OBERHEIM ELECTRONICS, INC.
ENGINEERING CHANGE ORDER

OB-8

SCHEMATIC 1679A SHEET 2

PROCESSOR BOARD 1679B SHEET 1 OF 4

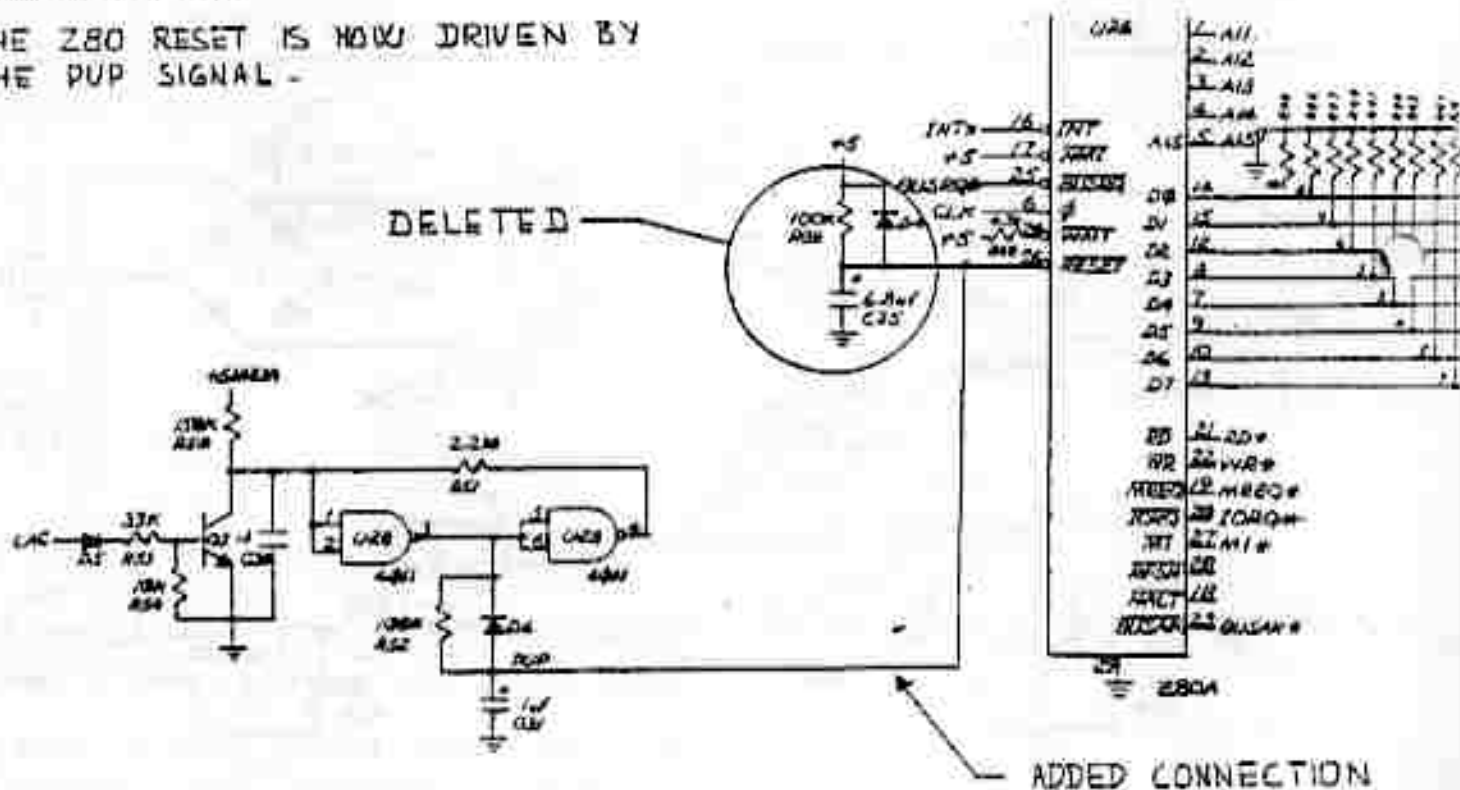
THE Z80 RESET IS NOW DRIVEN BY
THE PUP SIGNAL -

TO AVOID POSSIBLE MEMORY DROP CAUSED BY SHORT POWER DROP

DRAWINGS AFFECTED
POWER SUPPLY

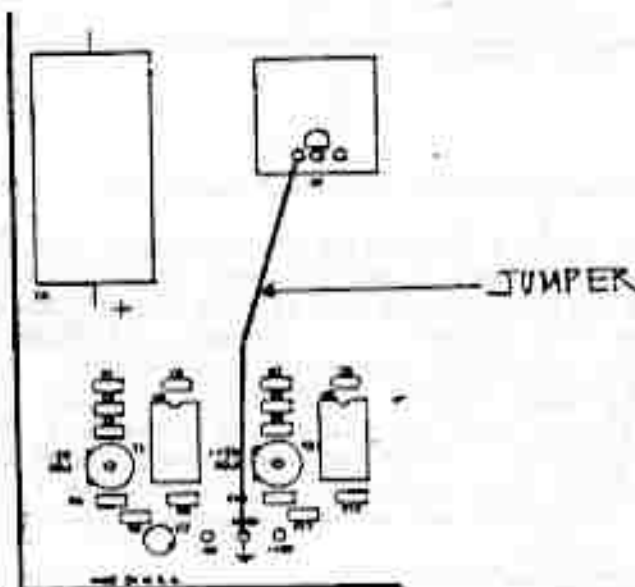
ADD A JUMPER BETWEEN PIN 1 OF THE -15 REGULATOR
7915 (GND) AND THE GROUND REFERENCE TEST POINT.
THE JUMPER MUST BE MADE OF A 18 AWG WIRE (.04 inch / 1 mm)
MINIMUM AND MUST BE SHORT.

TO REMOVE AC HUM ON AUDIO OUTPUT.

OB-8 PROCESSOR BOARD 1679B sheet 1 of 4

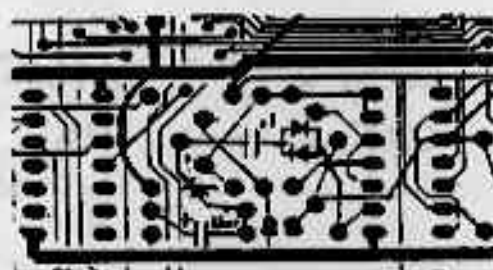
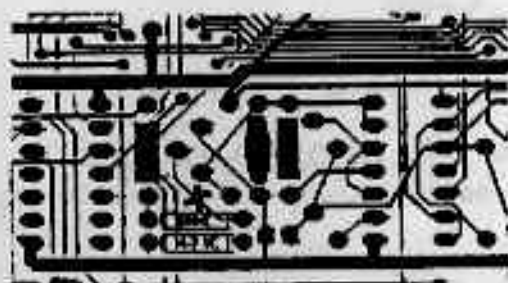
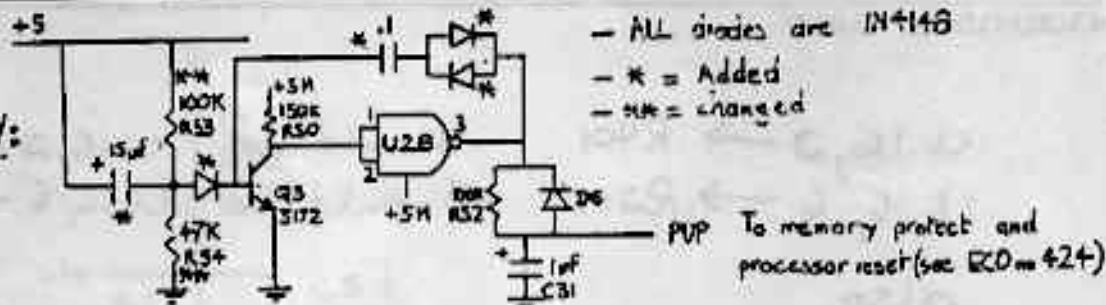
NEW PUP CIRCUITRY:

- Remove DS, C30, R31 (Darkened components)
- Cut between Q3 base and R53
- Remove diode added by ECO 423 (under the board)
- Replace R53 with a 100K and R54 with a 47K

- Add a jumper between +5 and R53
- Add from under the board: 2 caps and 3 diodes

- Replace C1 (4700 μF cap. on 5v power supply) with a 10,000 μF 16v

- Avoid memory drop.

ECO # 419

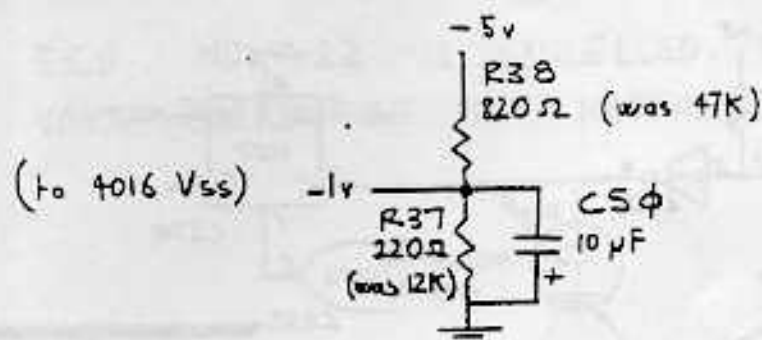
- change value of -1 divider on each voice board

- ALLOWS USE OF SIGNETICS' 4016 &
IDENTIFIES COMPONENTS

OB-B PROCESSOR BOARD 1679B short 2of4-

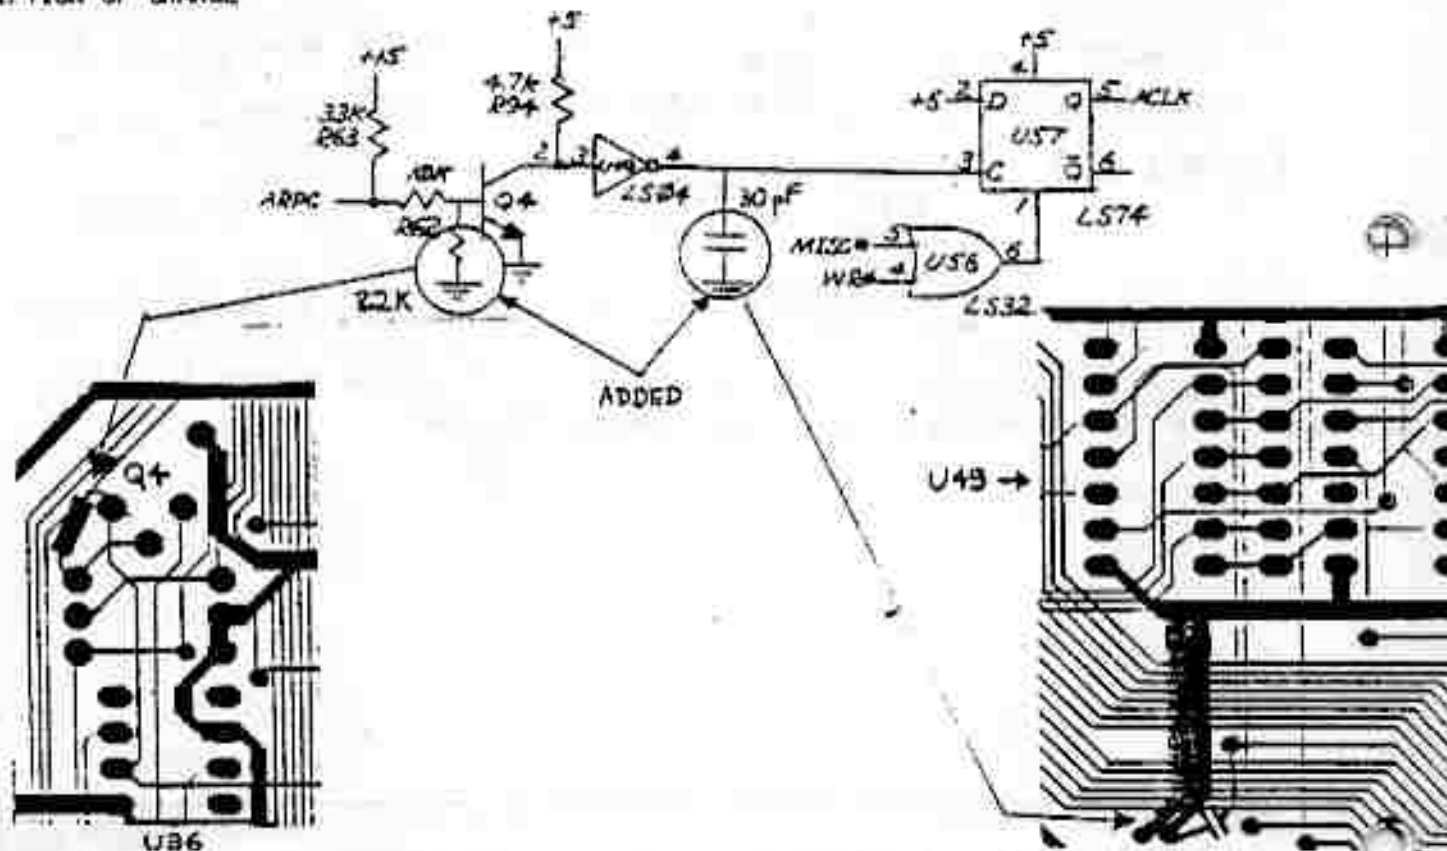
- AVOID MISSING *PULSE ON ARPEGGIATOR EXTERNAL CLOCK

08-8 MOD CAN SCHEMATIC
SHEET 1 OF 1.

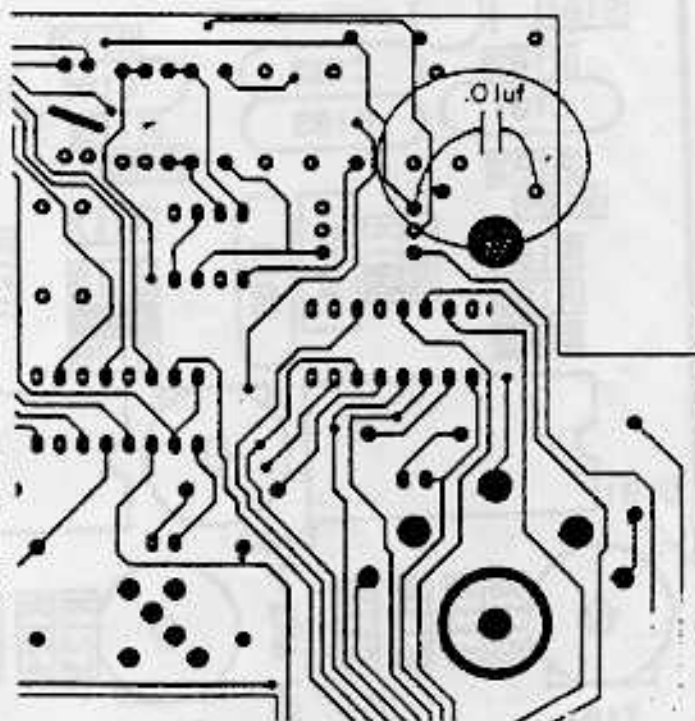
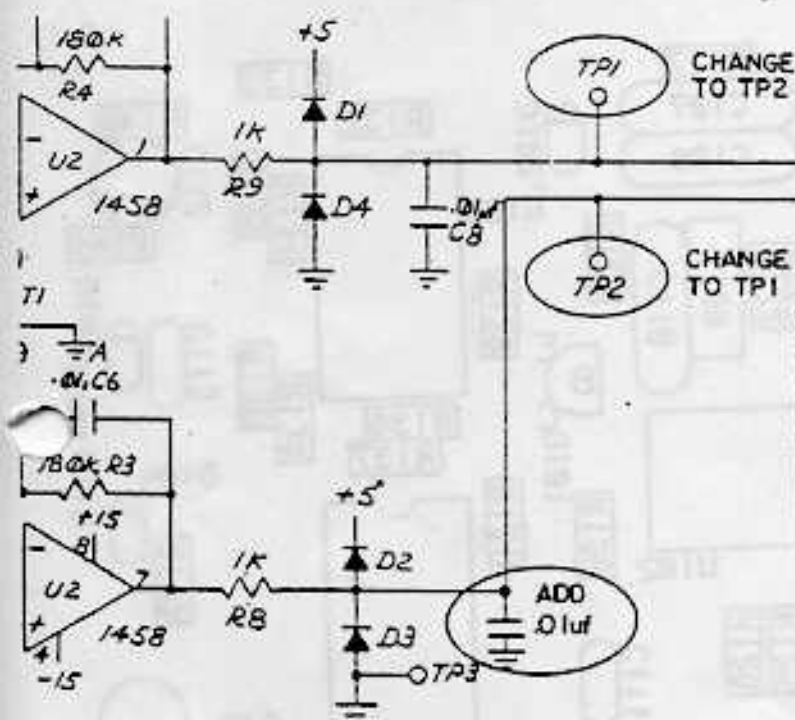
REMOVE NOISE MODULATION FROM
VIBRATO LEVER, AND CORRECT
SCHEMATIC.

1. CHANGE SCHEMATIC AS SHOWN.
2. ADD .01uF CAP (08.153004) FROM GROUND TO TEST POINT (T.P. 2) OF MOD CAN PCB ON 1666 SIDE OF BOARD.

DRAWINGS AFFECTED VOICE BOARD
SCHEMATIC 1682B SHEET 3 OF 3

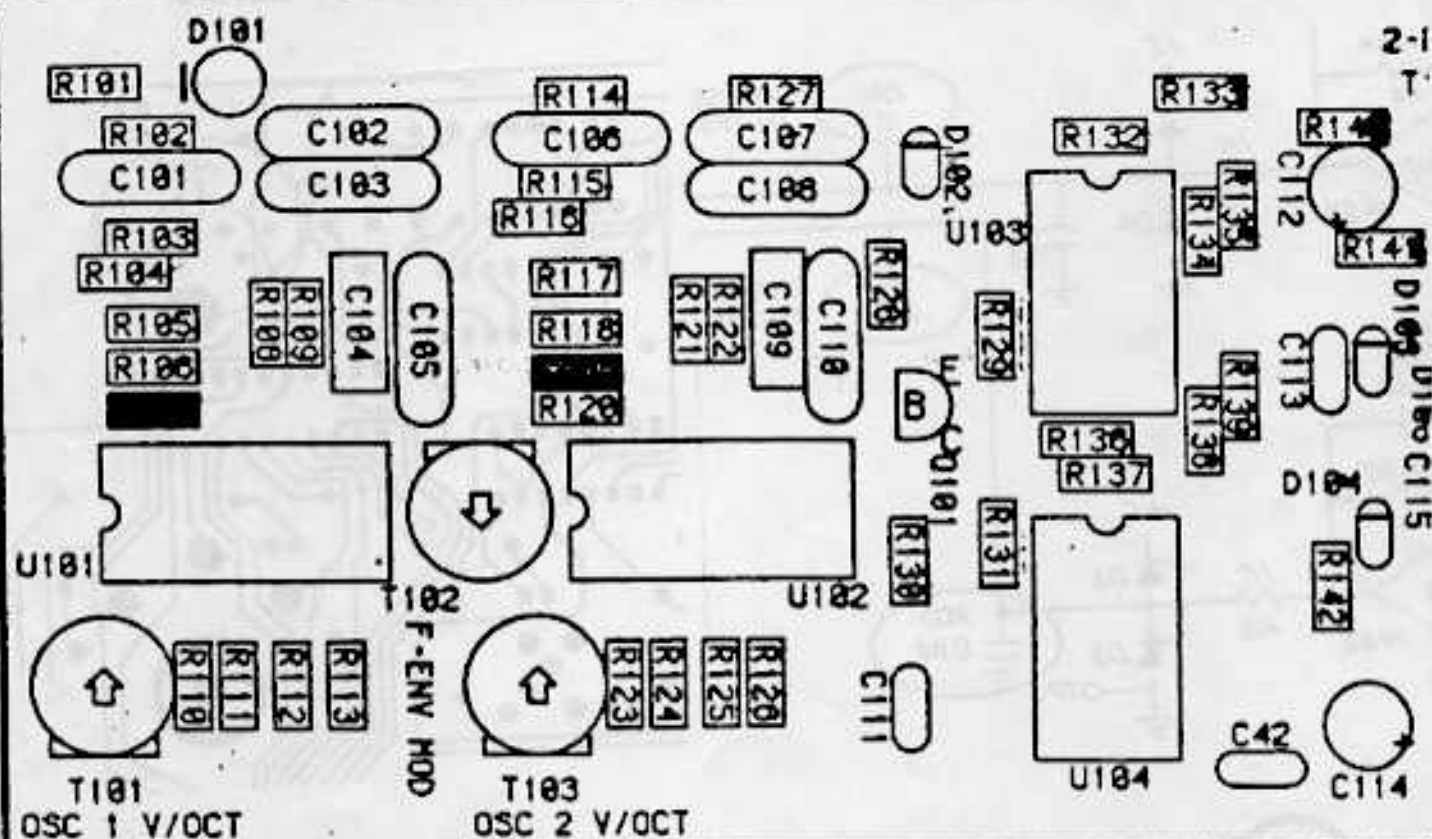
LOWER INITIAL FREQUENCY OF 3340
TO ACCOMMODATE A WIDER RANGE
OF CHARACTERISTIC VARIATIONS ON
THE 3340.

REPLACE RESISTOR RX07 AND RX19 (215K, 1%)
WITH 174K, 1% (OB#475520).
